April 19, 1982

SUBJECT: Modification of Female Keyboard Connector

581-228-SB1

FIELD ENGINEERING
COMPUTER SYSTEMS
TECHNICAL BULLETIN

Figure 2

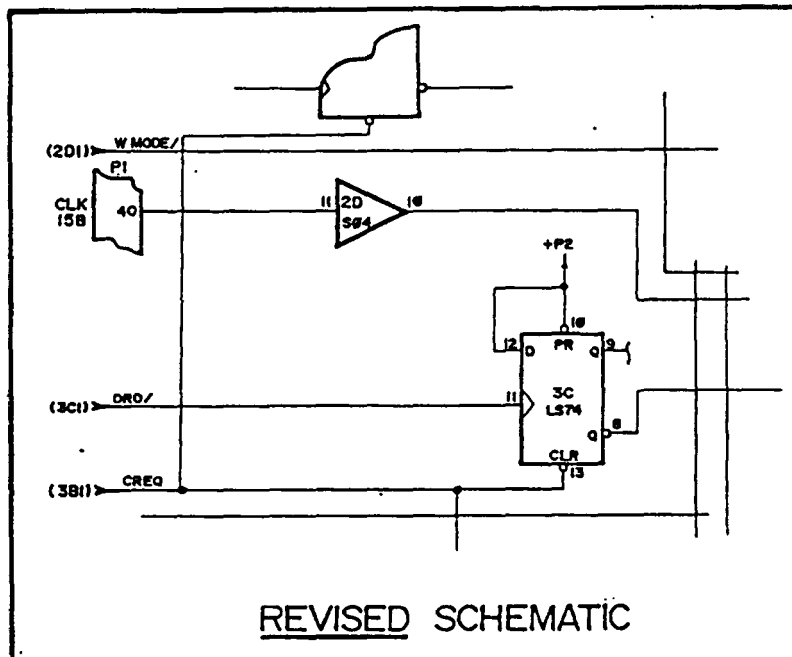
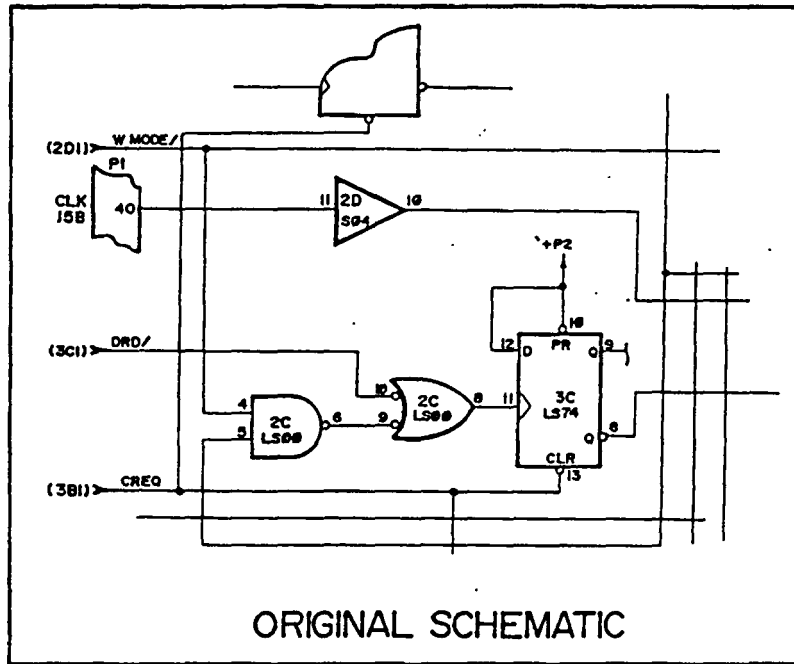
On Schematic 101161, Sheet 4, Area B7 delete Gates 2C (pins 4,5, and 6) and 2C (pins 8,9, and 10) as shown below.

Figure 1

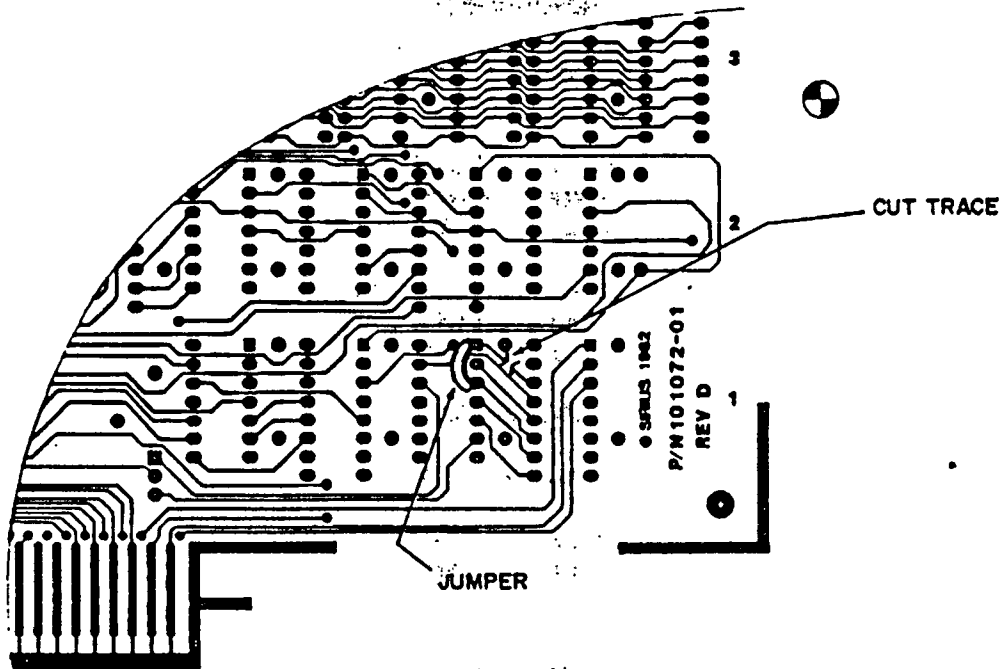
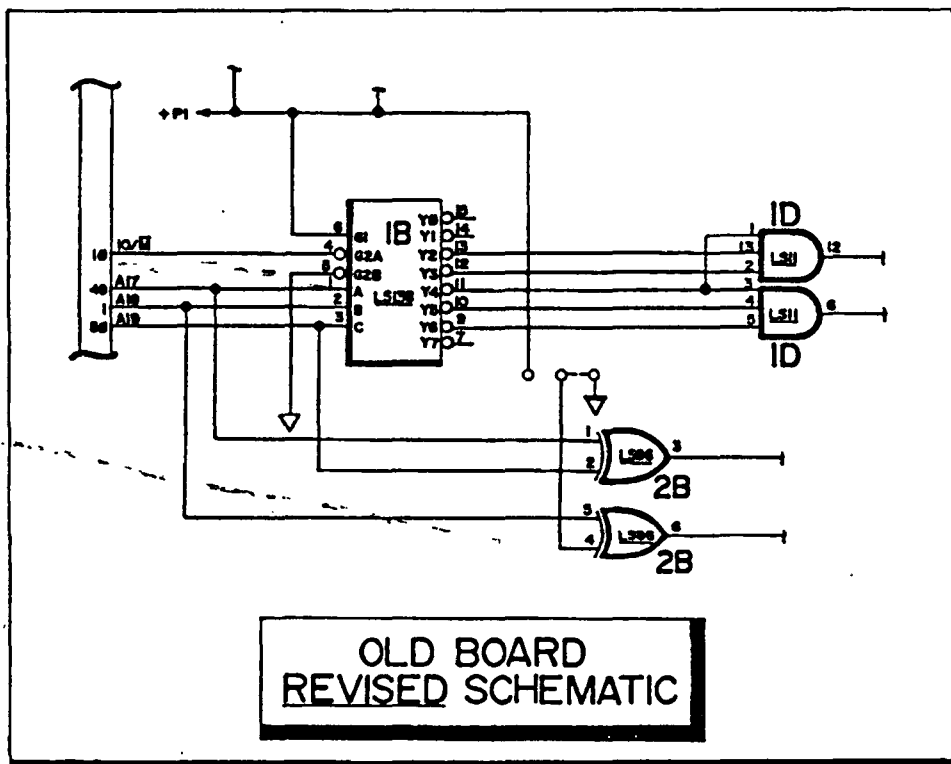
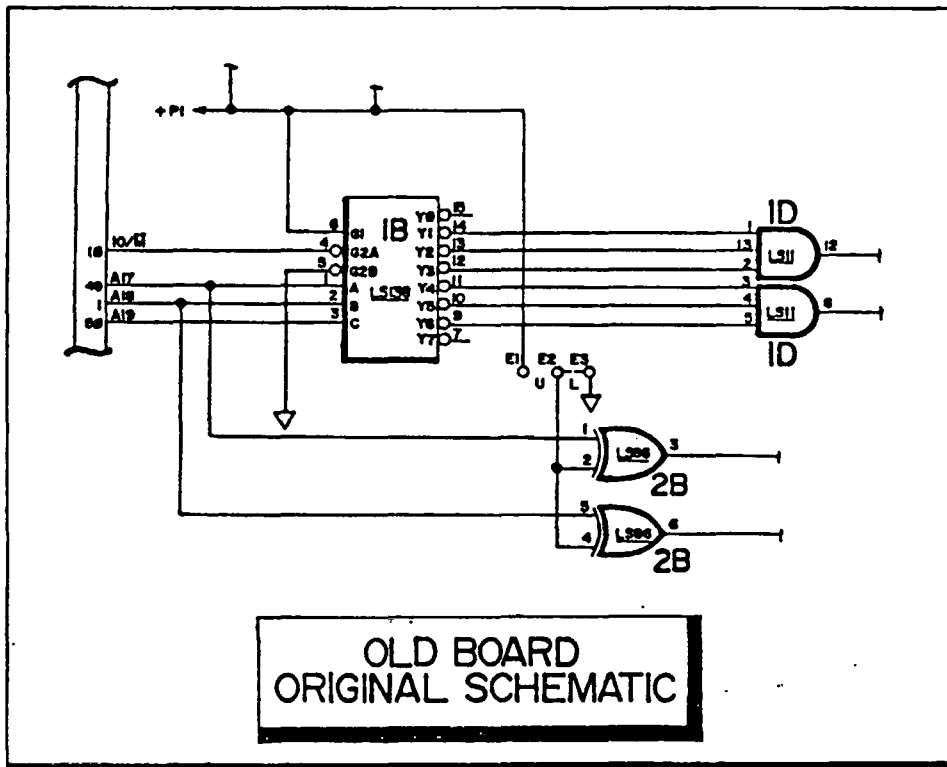
OLD STYLE BOARD: (Refer to figures 1 and 2.)

1. Install a jumper from E2 to E3 and one from E4 to E6, if not already installed.
2. Cut pin 1 of IC 1D, 74LS11, as close to the board as possible. Bend pin 1 up away from its solder pad. Solder a jumper from pin 1 of IC 1D to pin 3 of IC 1D.
3. Cut pin 2 of IC 2B, 74LS86, as close to the board as possible. Bend pin 2 up away from its solder pad. Solder a jumper from pin 2 of IC 2B to pin 3 of IC 1B, 74LS138.

NEW BOARD REVISED SCHEMATIC

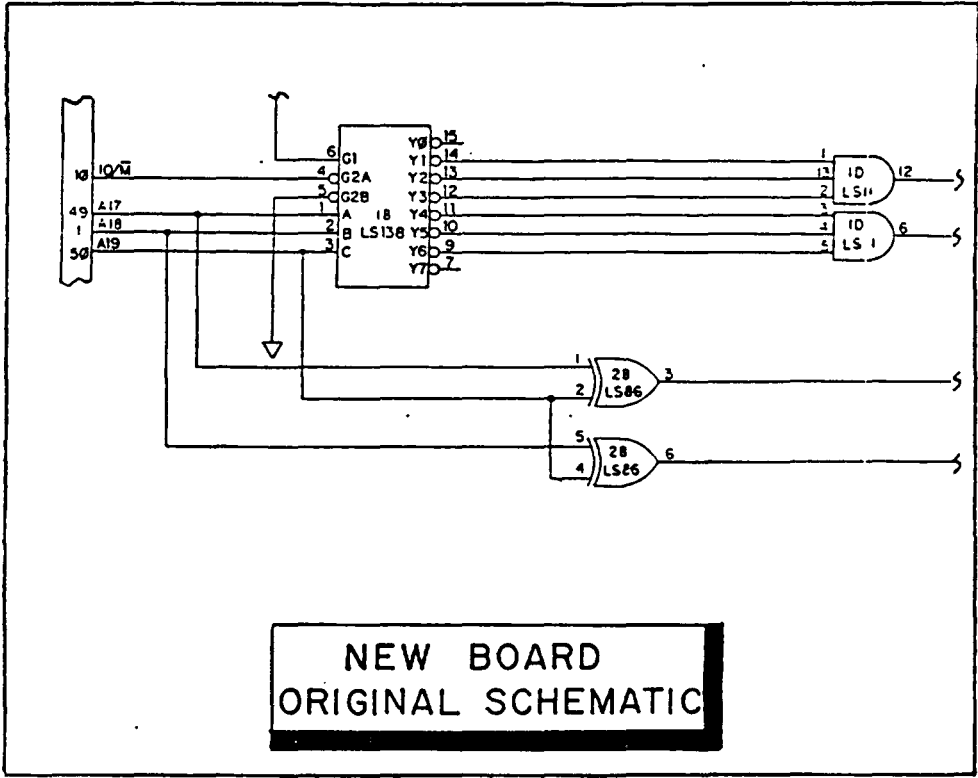
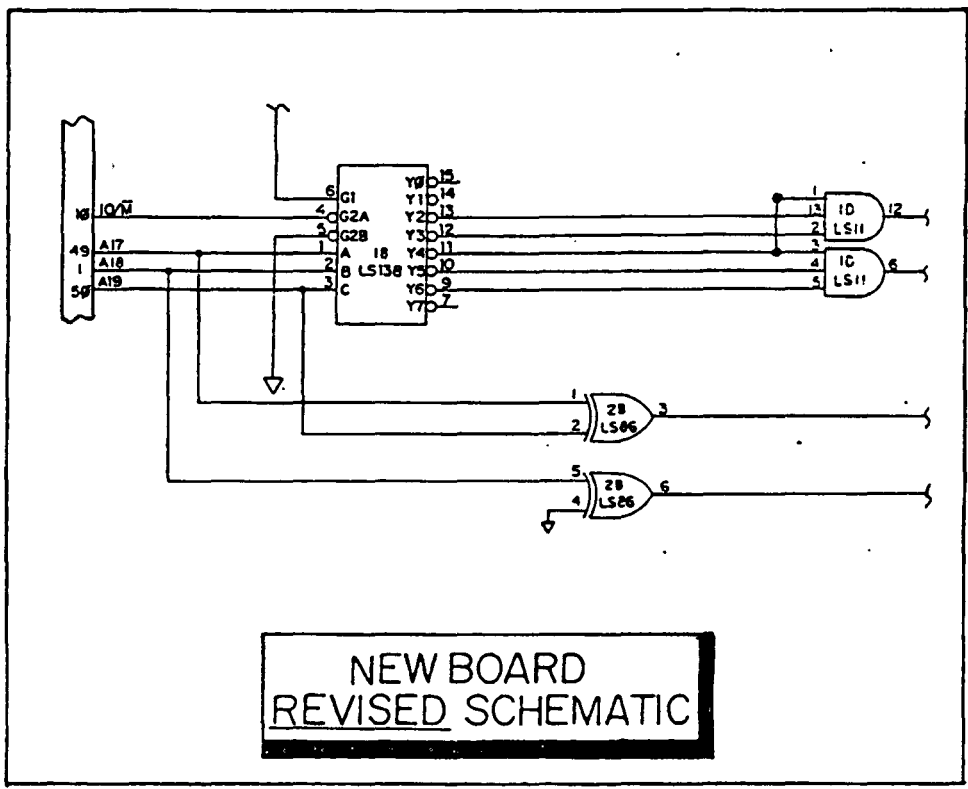
Memory selection jumper styles were revised after initial production for ease of installation. New style boards have a jumper plug. Old style boards which have 2 soldered jumpers. Normal starting addresses for the 384K board are 2000:0 for lower strapping and 8000:0 for upper strapping. This modification changes the starting address to 4000:0. All modified boards must be strapped lower.
